Access Compliance Report

(Curb Ramps)

Intersection ID: 48696	Main Street: MONTGOMERY_GARDENS_DR	Cross Street: BEATTIES_FORD_RD	Location:	N
ADA ID: A493523FB389	Ramp Type: PerpDiag	Initial Pass/Fail: Fail	Overall Compliance: No	Severity Score: 22.5
Codes/Mitigation Info/Possible Solution		Field Measurements/Component Compliance

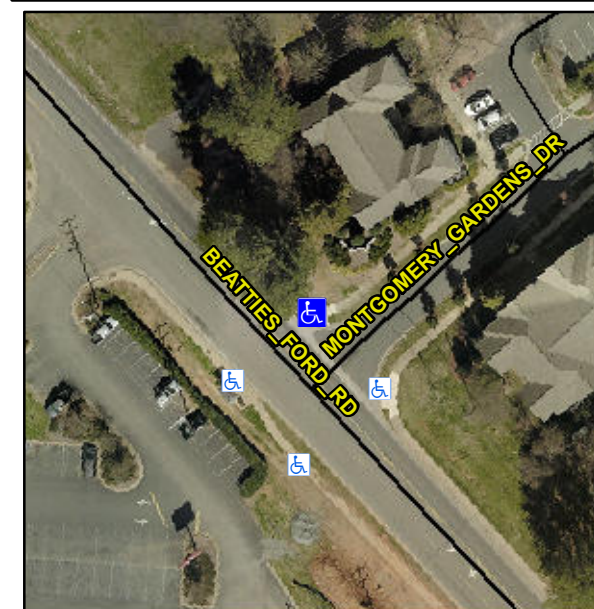
Not Found, R304.5.1, R304.2.2, R304.5.3

Compliance	Description	Data	Compliance	Description	Data
N/A	Ramp Length (in)	48.0	No	Ramp Slope (%)	8.8
No	Ramp Width (in)	46.5	No	Ramp XSlope (%)	2.1
N/A	Flare Type LT	N/A	N/A	Flare Type RT	N/A
N/A	Flare Slope LT (%)	N/A	N/A	Flare Slope RT (%)	N/A
N/A	Flare Traversable LT?	N/A	N/A	Flare Traversable RT?	N/A
N/A	Landing Length (in)	N/A	N/A	DWS Provided?	N/A
N/A	Landing Width (in)	N/A	N/A	DWS Contrast?	N/A
N/A	Landing Slope (%)	N/A	N/A	DWS Length (in)	N/A
N/A	Landing X Slope (%)	N/A	N/A	DWS Full Width?	N/A
N/A	Landing Curb? (Y/N)	N/A	N/A	DWS Offset (in)	N/A
N/A	Shared Landing?	N/A			
N/A	Gutter Ponding?	N/A	N/A	Gutter Slope (%)	N/A
N/A	Gutter Lip Ht (in)	N/A	N/A	Gutter X Slope (%)	N/A
N/A	Painted X Walk1?	No	N/A	Painted X Walk2?	No
	X Walk 1 Direction	To SW		X Walk 2 Direction	To SE
N/A	X Walk 1 Width (in)	N/A	N/A	X Walk 2 Width (in)	N/A
	X Walk 1 Slope (%)	1.5		X Walk 2 Slope (%)	0.0
	X Walk 1 X Slope (%)	1.2		X Walk 2 X Slope (%)	3.2

Remove & Replace Curb Ramp With Two New Directional Ramps or Equivalent.
